PROPOSED CONVERSION &
EXTENSION OF FORMER POST
OFFICE SORTING OFFICE INTO
DWELLING AT No 6,
THE AVIARY, REFORM STREET,
CROWLAND FOR

ELEVATIONS AS PROPOSED

1:50 SD08-018/3
APRIL-08 B.GILHAM.

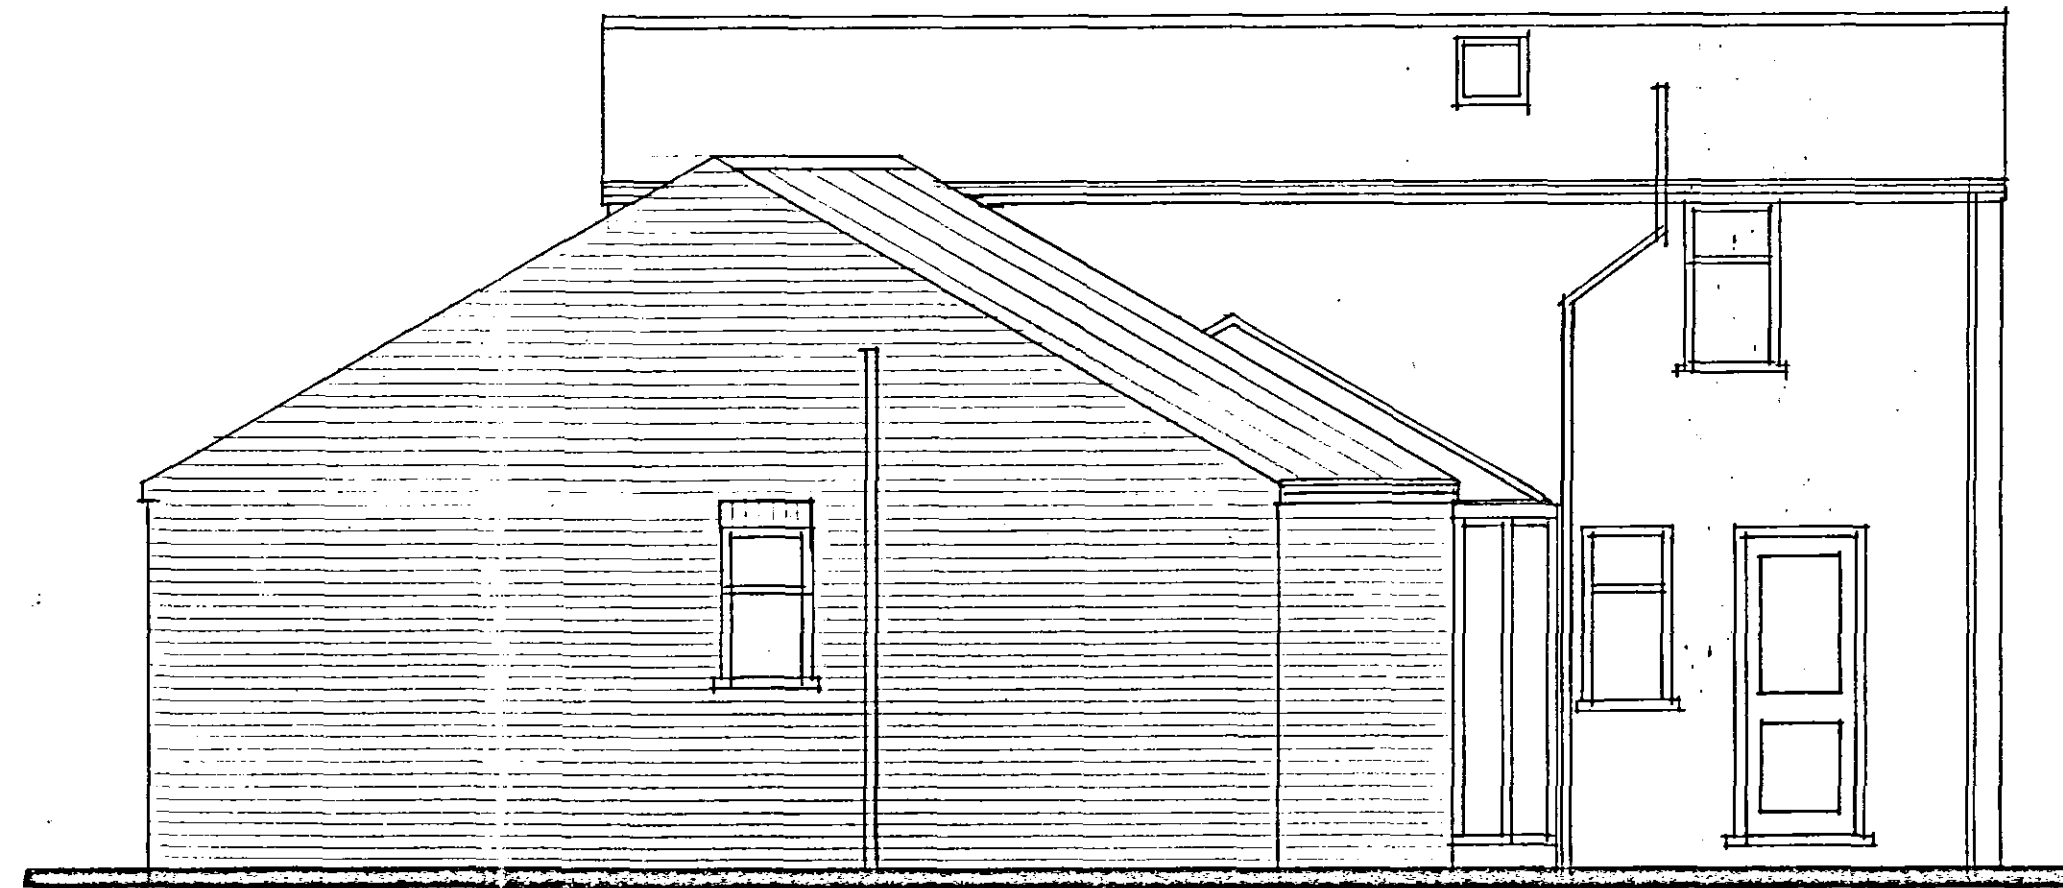
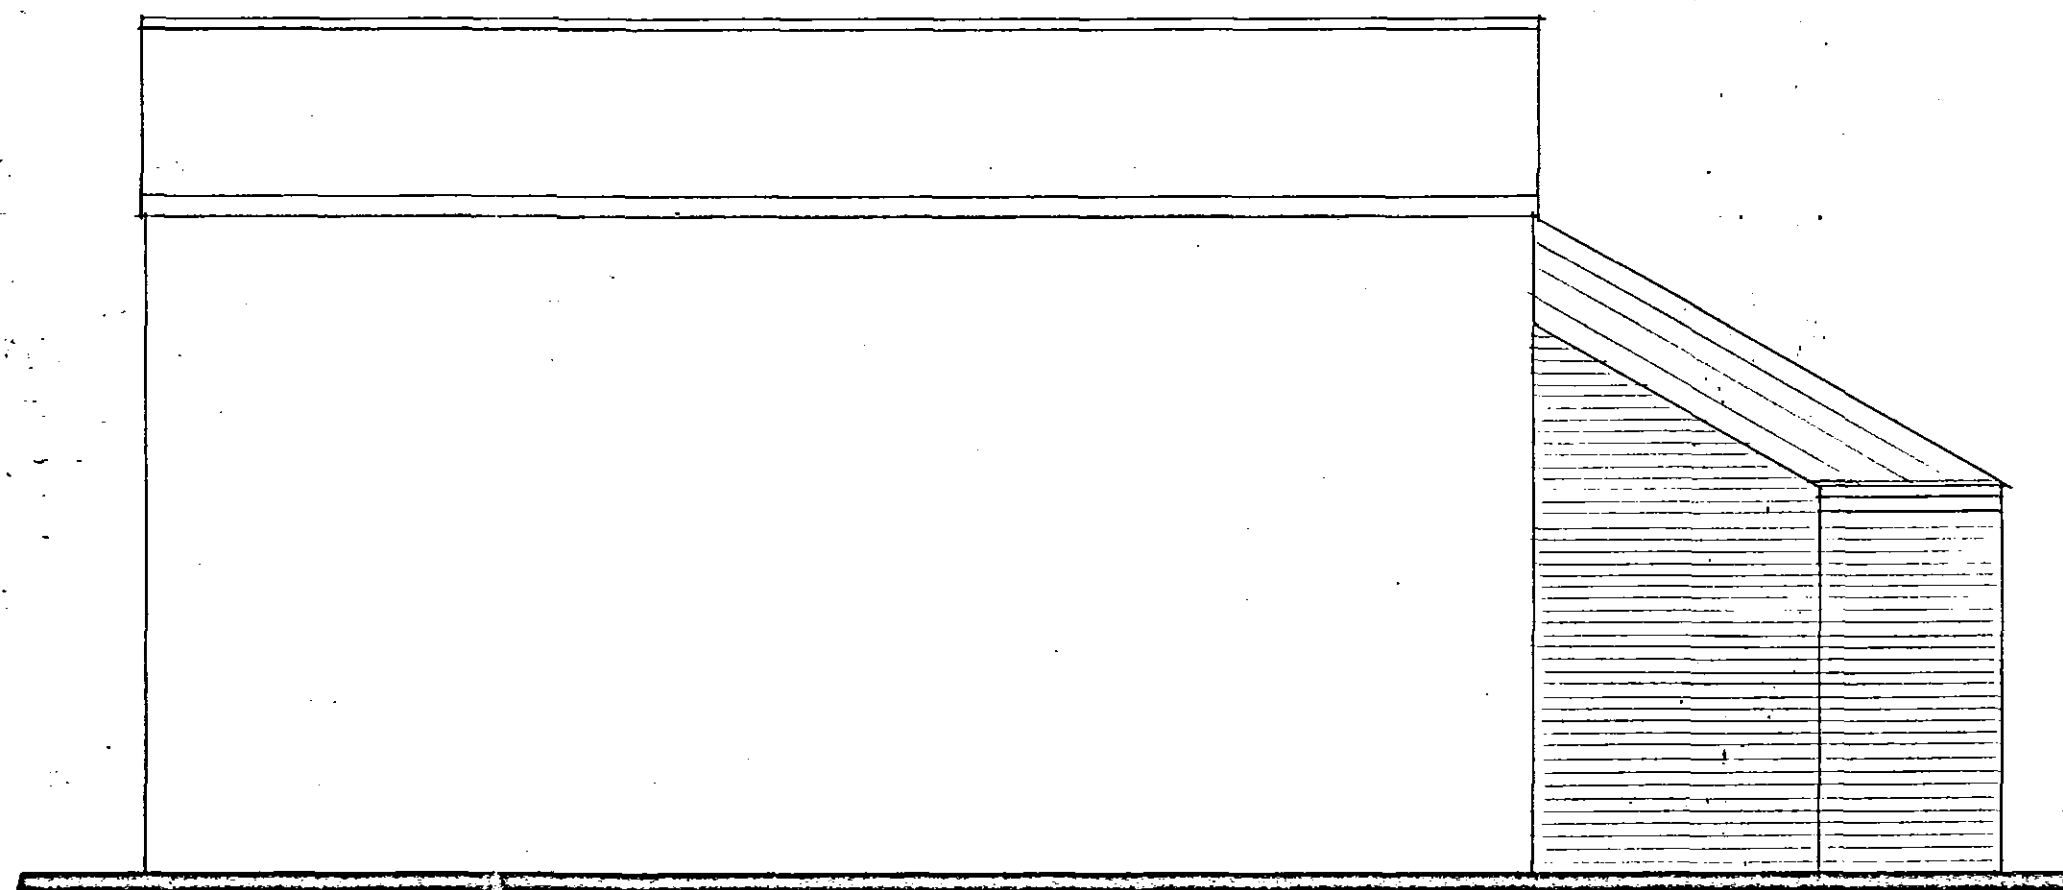
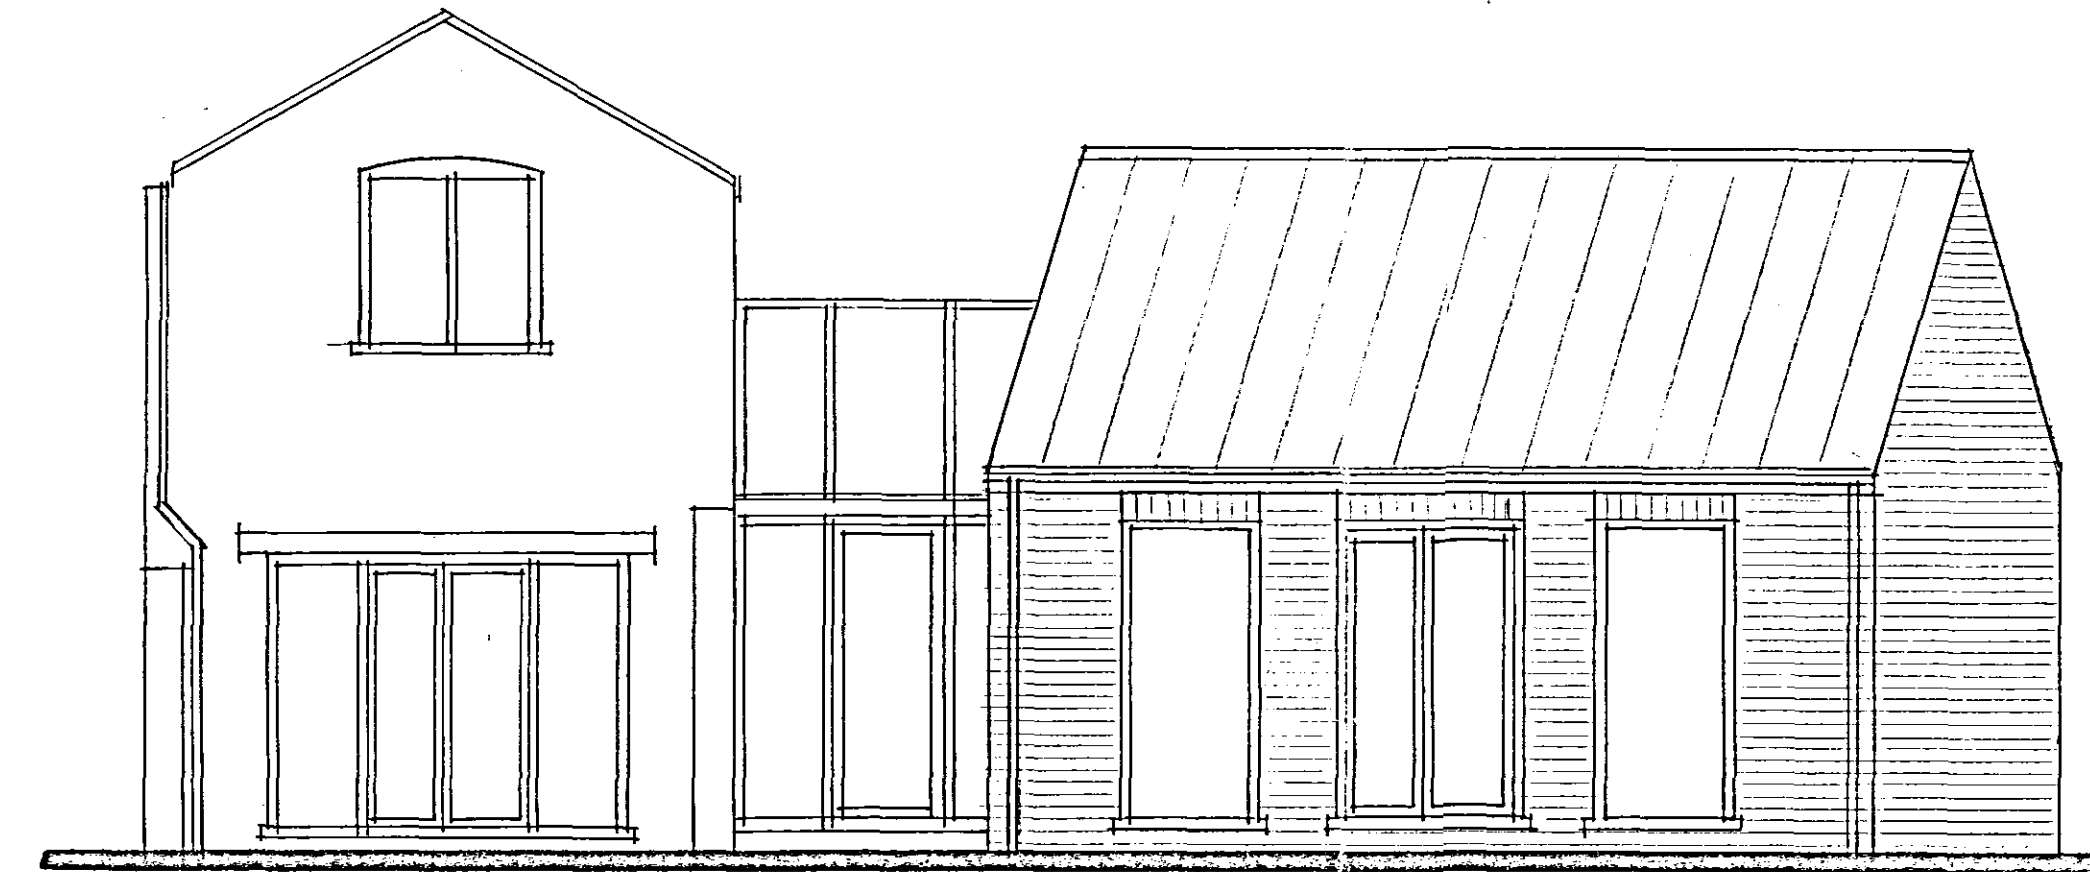
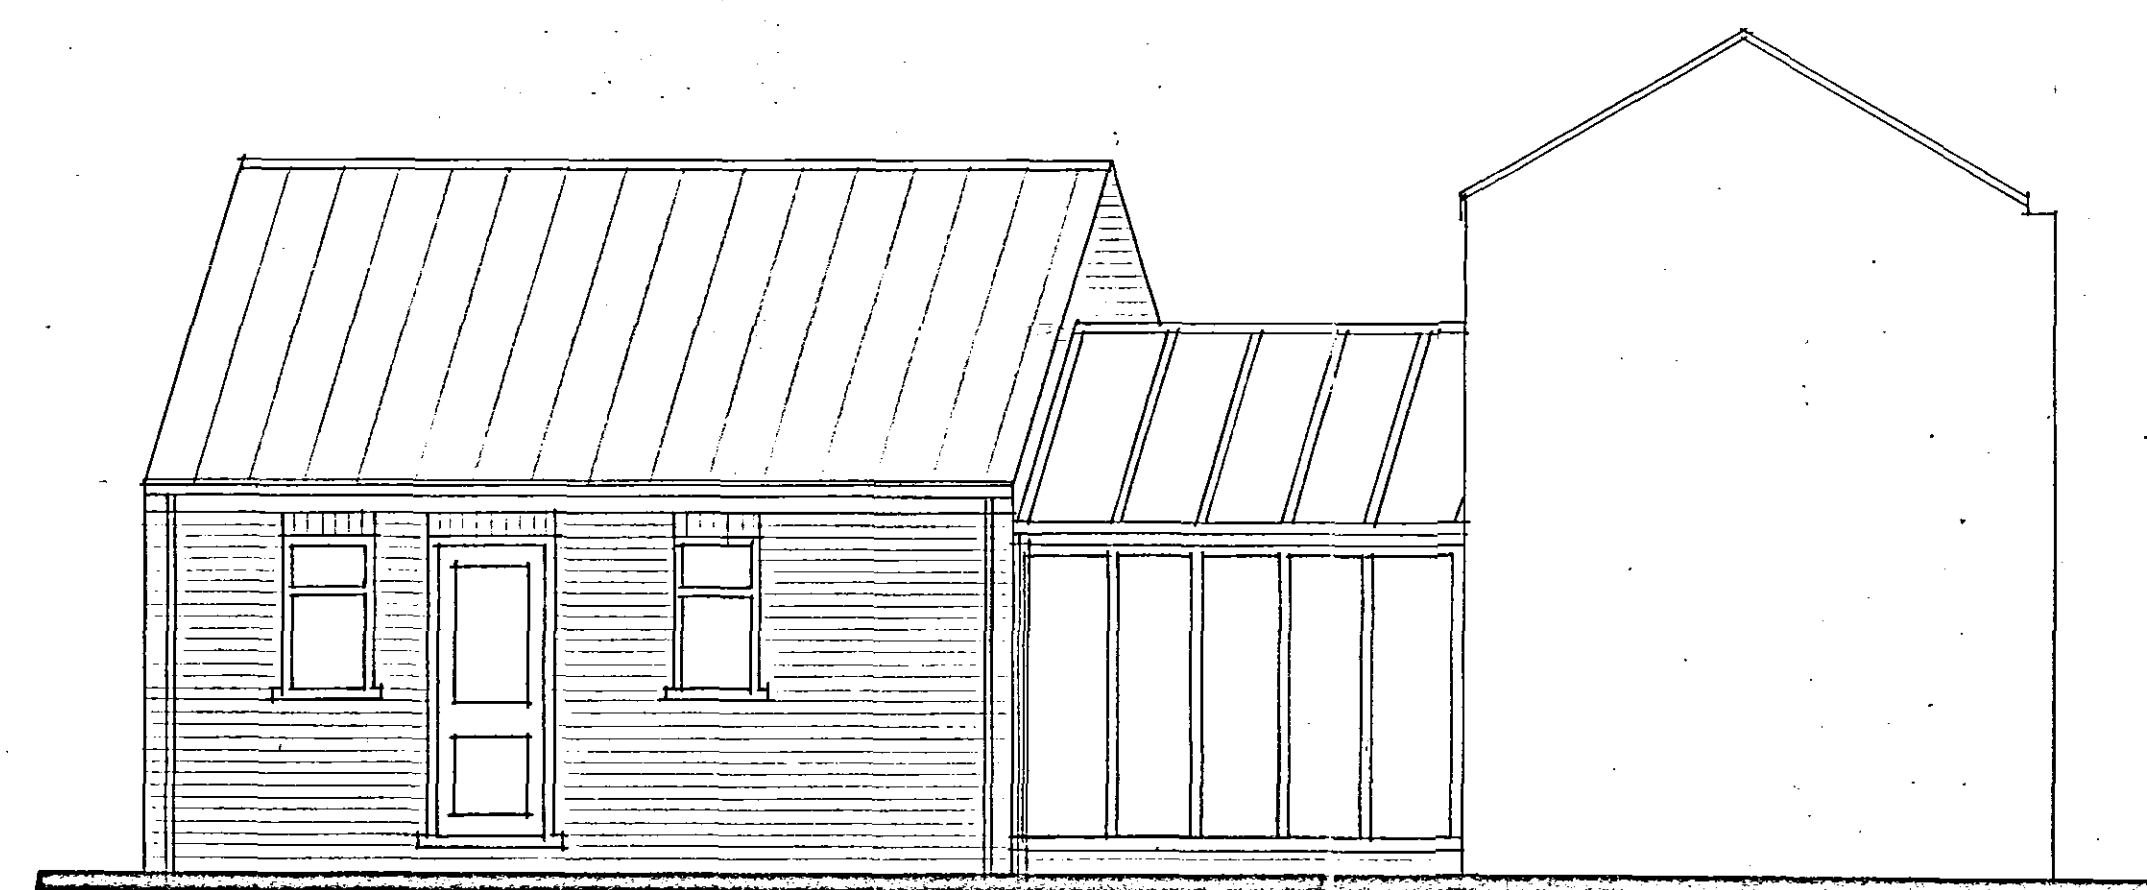
UPVC windows/doors
not appropriate.

Scale of extension excessively
large compared to exst. building

Difference in depth of plan
form means roof forms are
fairly different
